**Sling Aircraft (Pty) Ltd**  
**Registration no 2002/022837/07**  
Approved Maintenance Organisation AMO1264  
Manufacturing Organisation M677

## SERVICE BULLETIN

#0022

**SUBJECT:** Replacement of improperly de-embrittled bolts

Figure 1: Sling 2 engine mount to engine frame attachment

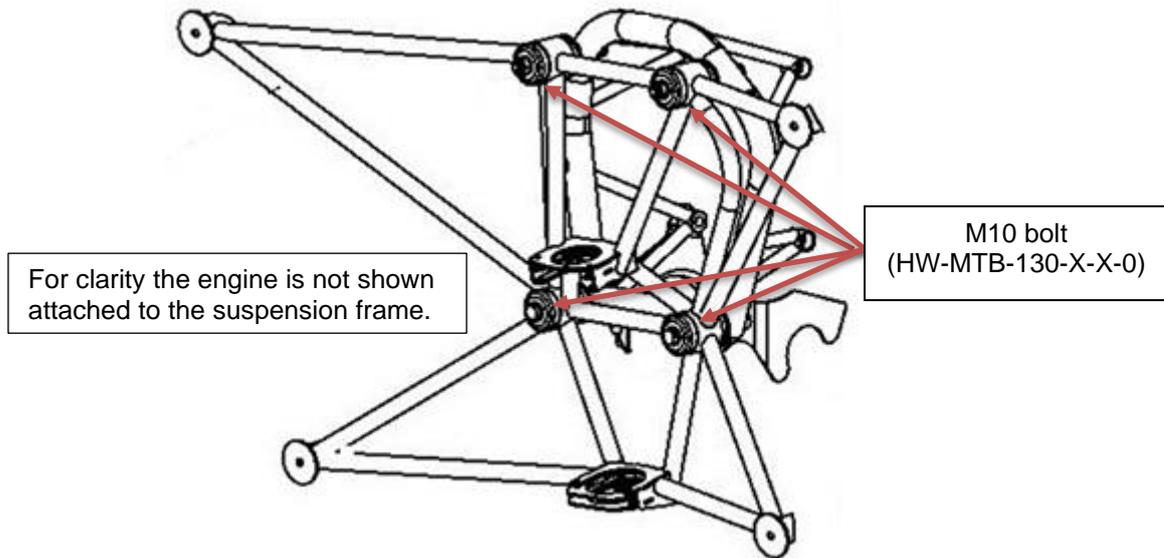
- Step 1: Before any bolts can be replaced, the aircraft's cowling needs to be removed. To do so, refer to the Sling 2 & Sling LSA Maintenance manual (DC-MAM-002-X-B) Section 5.1.1.
- Step 2: The four M10 bolts (HW-MTB-130-X-X-0) that mount the engine to the engine frame need to be replaced. These bolts can be seen in the exploded view of the engine mount in Figure 1.

It is possible to replace the M10 bolts one at a time, without uninstalling the engine.

Figure 2: Rotax 912 iS engine anchor points

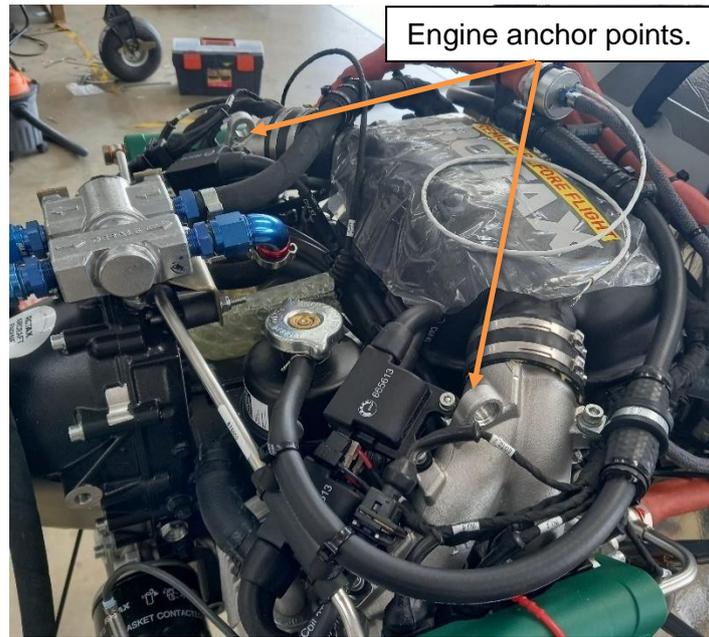
- Step 3: Before any bolts are removed, the engine must be supported. This is to prevent the engine from getting damaged should it drop during the bolt removal, as well as to relieve some strain on the bolts for easy removal. The engine can be supported by the anchor points located on the top of the engine, as shown in Figure 2.

Figure 3: Bolt replacement sequence

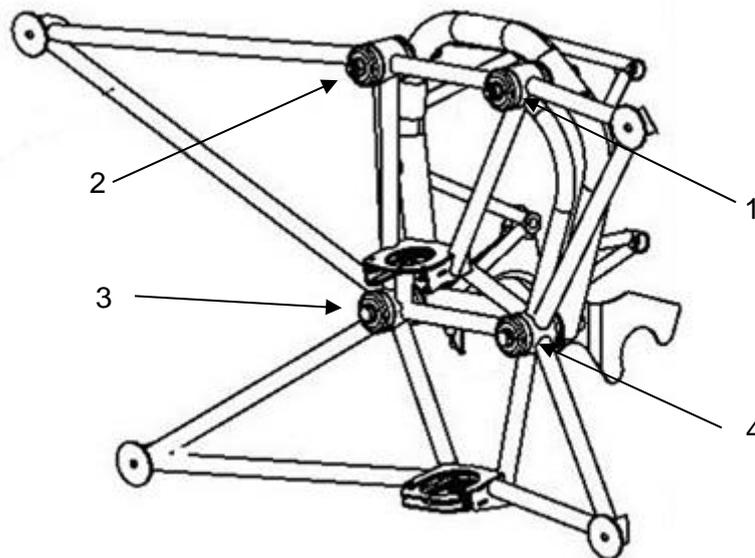
Step 4: Once the engine is supported, the bolts can be replaced *one by one*. Refer to Figure 3 and replace the bolts in order. Remove bolt 1 and install a new bolt. Torque the bolt to 38 Nm. Ensure all washers, rubber stoppers and spacers are installed in the correct positions when replacing the bolts. Once bolt 1 has been replaced and torqued to 38 Nm, replace bolt 2, which should then also be torqued to 38 Nm.

Figure 4: Detaching of the Rotax 912 iS exhaust.

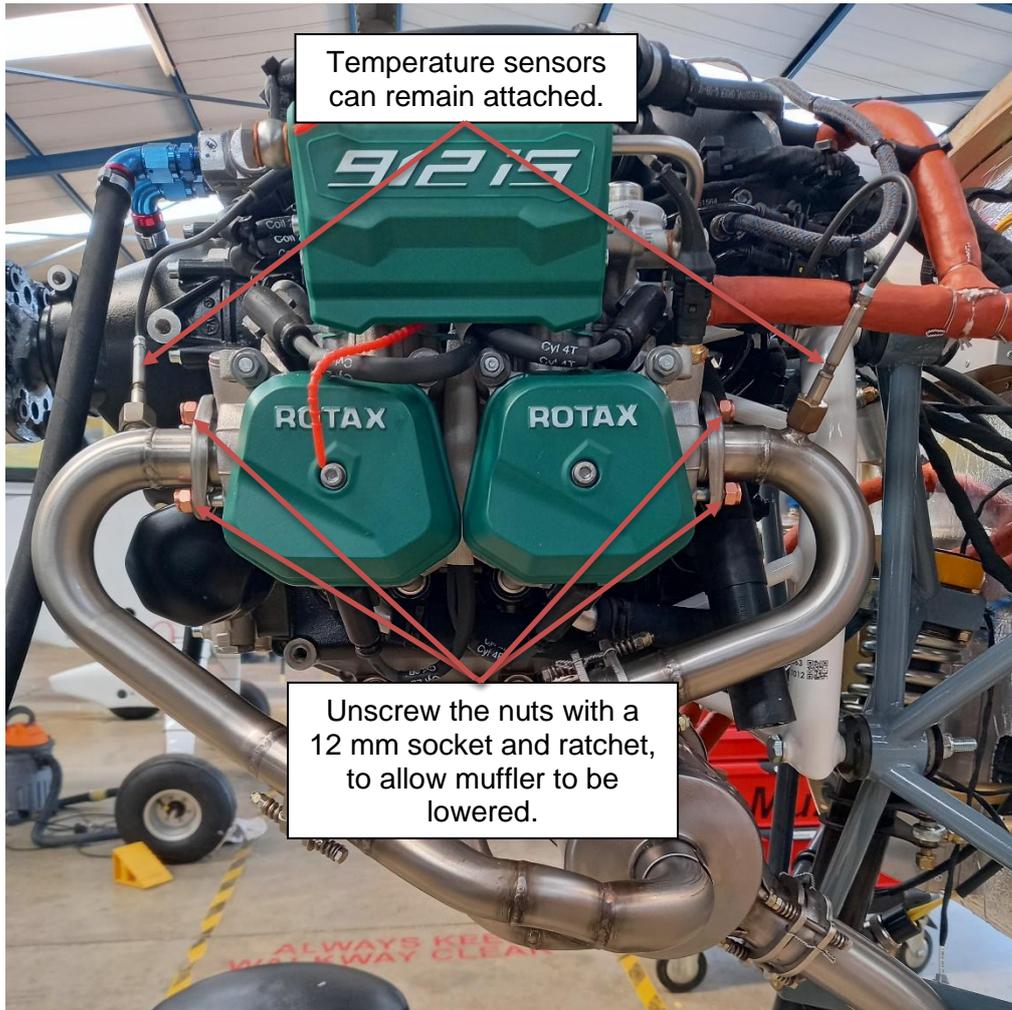
Step 5: Before bolts 3 and 4 can be replaced the muffler needs to be lowered, to create enough clearance to remove the bolts. As shown in Figure 4, the nuts holding the exhaust pipes to the engine should be unscrewed to allow the pipes to detach from the engine. Do not detach the exhaust tubes from the muffler. This must be done for both the left- and right-hand side of the engine so that the exhaust can detach on both sides of the aircraft. The

two temperature sensors on each exhaust pipe can remain attached as there should be sufficient play in the wire length to lower the muffler enough to remove the bolts.

Figure 5: Sling 2 muffler ring clamps

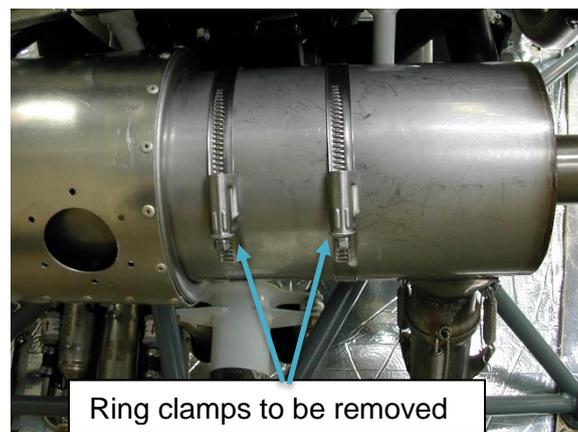
Step 6: There are two ring clamps that restrain the muffler. Before it can be lowered, these ring clamps must be removed.

- Step 7: Once the ring clamps have been removed, the muffler can be lowered enough for bolts 3 and 4 to be removed. The muffler should then be supported so that you don't have to hold it while you remove Bolt 3.
- Step 8: After bolt 3 has been removed, install a new bolt. Ensure all washers, rubber stoppers and spacers are installed in the correct positions when replacing the bolt, as seen in Figure 3. Once bolt 3 has been replaced and torqued to 38 Nm, replace bolt 4, which should then also be torqued to 38 Nm.
- Step 9: Reinstall the exhaust once the bolts have been replaced.
- Step 10: Apply torque seal to the bolts on both ends, once all the bolts have been torqued to the correct torque value of 38 Nm.
- Step 11: Once all 4 bolts have been replaced, reinstall the cowling, refer to the Sling 2 & Sling LSA Maintenance Manual (DC-MAM-002-X-B) Section 5.1.1.

Figure 6: M8 bolts connecting the propeller extension and engine flange

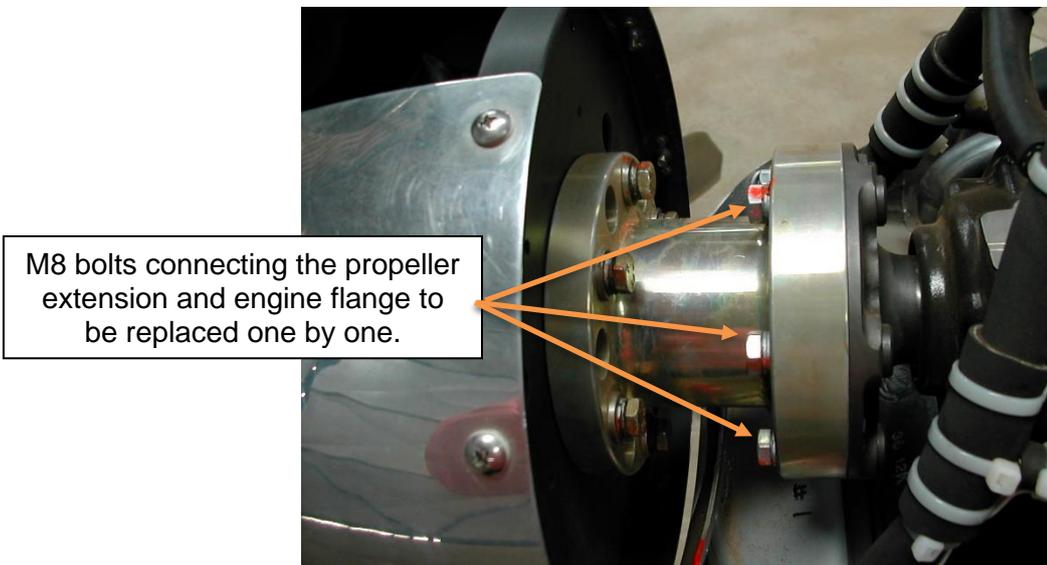
- Step 1: Before any bolts can be replaced, the aircraft's cowling needs to be removed. To do so, refer to the Sling 2 & Sling LSA Maintenance Manual (DC-MAM-002-X-B) Section 5.1.1.
- Step 2: It is possible to replace the M8 bolts (HW-MTB-840-X-X-0) without removing the propeller.
- Step 3: The bolts that need to be replaced are the M8 bolts connecting the propeller extension and engine flange. Refer to Figure 6.

Figure 7: Propeller extension bolt replacement sequence

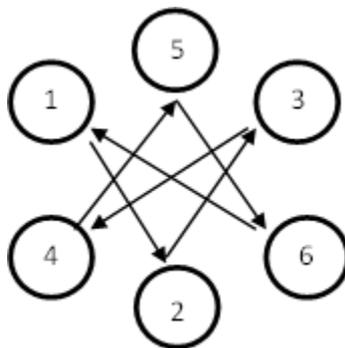
- Step 4: Support the propeller and replace the M8 bolts one by one. This will allow the propeller to remain attached during the replacement process. The bolts should be replaced in accordance with the sequence shown in Figure 7. Loctite 243 should be applied to the threaded section of each replacement bolt before it is installed. Ensure that only one bolt is replaced at a time, and it gets torqued to the correct torque value of 24 Nm, before the next bolt is replaced.

- Step 5: Once all the bolts have been torqued to the correct torque value, apply torque seal to the bolt.
- Step 6: Once all 6 bolts have been replaced, reinstall the cowling, refer to the Sling 2 & Sling LSA Maintenance Manual (DC-MAM-002-X-B) Section 5.1.1.

Figure 8: Sling 4 TSi engine mount to engine frame attachment

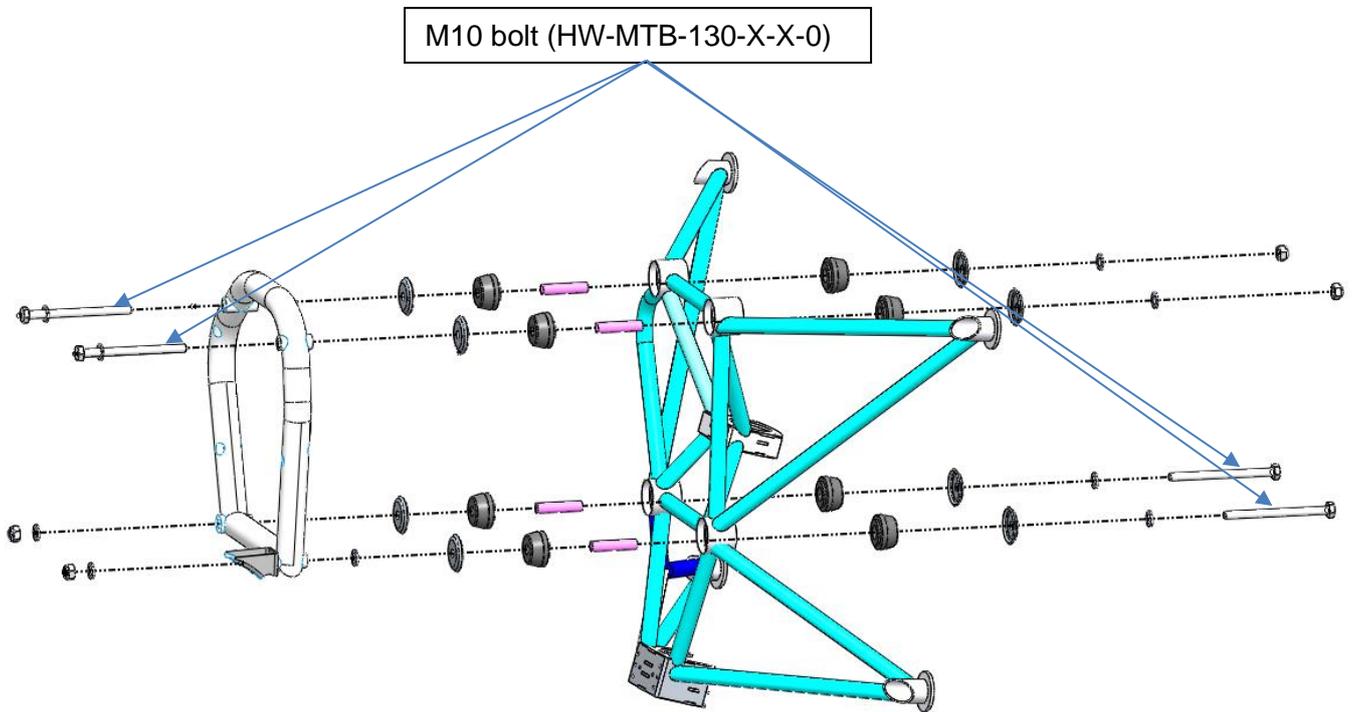
- Step 1: Before any bolts can be replaced, the aircraft's cowling needs to be removed. To do so, refer to the Sling 4 TSi Maintenance Manual (DC-MAM-001-X-F) Section 5.1.1.
- Step 2: The four M10 bolts (HW-MTB-130-X-X-0) that mount the engine to the engine frame need to be replaced. These bolts can be seen in the exploded view of the engine mount in Figure 8.

It is possible to replace the M10 bolts one at a time, without uninstalling the engine.

Figure 9: Rotax 915 iS engine anchor points

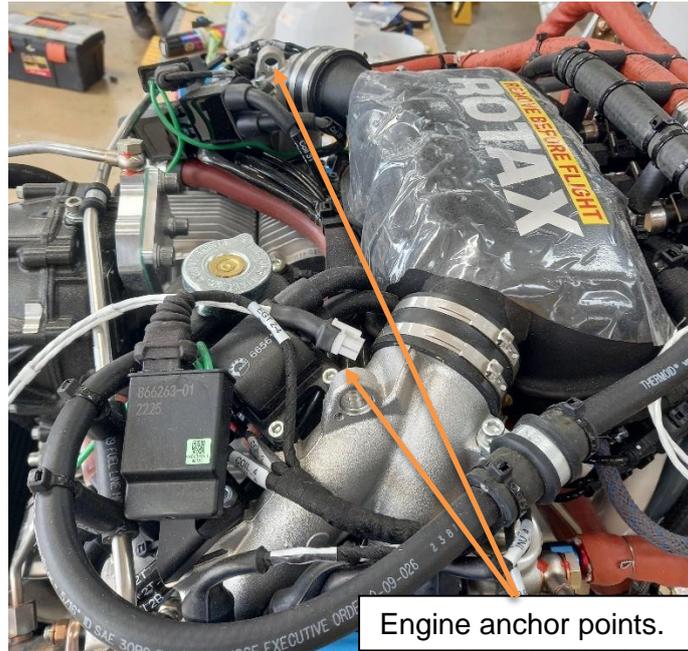
- Step 3: Before any bolts are removed the engine must be supported. This is to prevent the engine from getting damaged should it drop during the bolt removal, as well as to relieve some strain on the bolts for easy removal. The engine can be supported by the anchor points located on the top of the engine, as shown in Figure 9.

Figure 10: Bolt replacement sequence

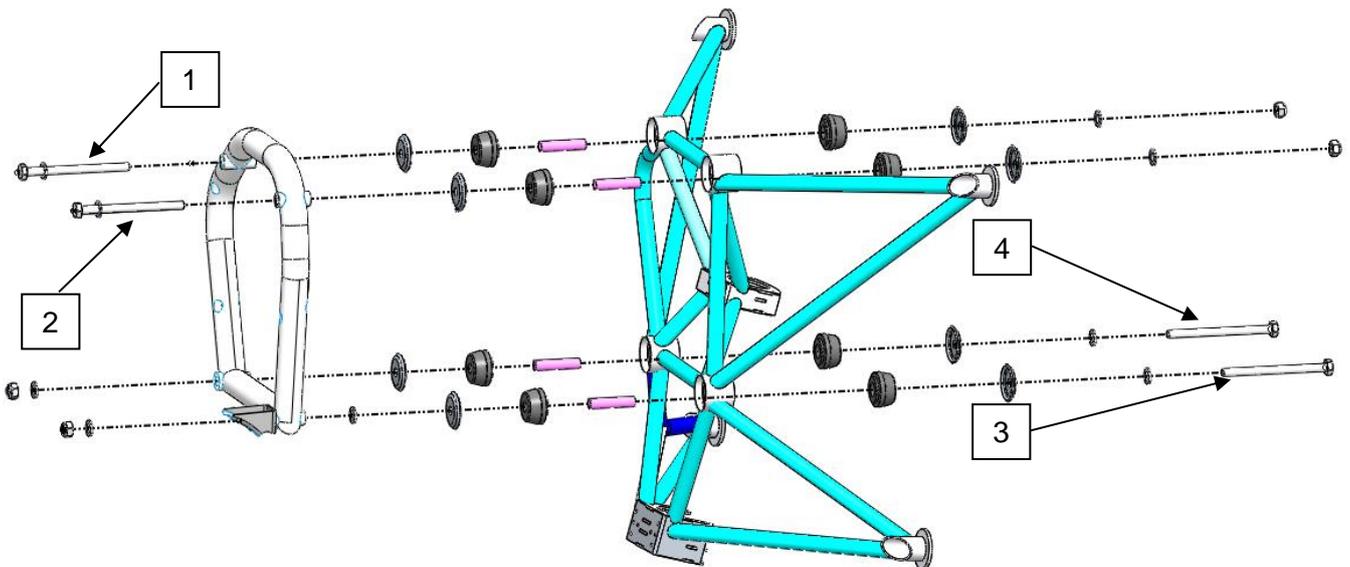
Step 4: Once the engine is supported, the bolts can be replaced *one by one*. Refer to Figure 10 and replace the bolts in order. Remove bolt 1 and install the new replacement bolt. Torque the bolt to 38 Nm. Once bolt 1 has been replaced and torqued to 38 Nm, replace bolt 2. Repeat this process until all 4 bolts have been replaced. All bolts should be torqued to 38 Nm. Ensure all washers, rubber stoppers and spacers are installed in the correct positions when replacing the bolts, as seen in Figure 10. The muffler of the Sling 4 TSi does not need to be lowered in order to replace the M 10 bolts shown in Figure 10.

- Step 5: Once all the bolts have been torqued to the correct torque value, apply torque seal to the bolt on both ends.
- Step 6: Reinstall the cowling. To do so, refer to the Sling 4 TSi Maintenance Manual (DC-MAM-001-X-F) Section 5.1.1.
